#### ADDENDUM #002

Solicitation Number: FDC ITB-20-049

**Solicitation Title:** Windows for Jefferson Correctional Institution

Addendum Number: 002

# WINDOW ELEVATION

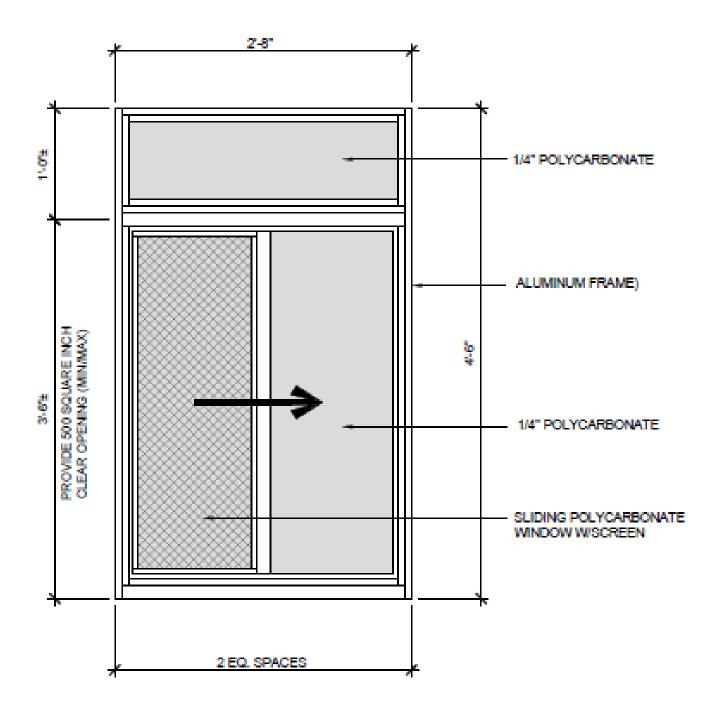
Section 2.1.10, Window Elevation, is hereby added as follows:

The window elevation shall be in accordance with Attachment IV - Window Elevation.

Attachment IV – Window Elevation is hereby added and attached hereto.
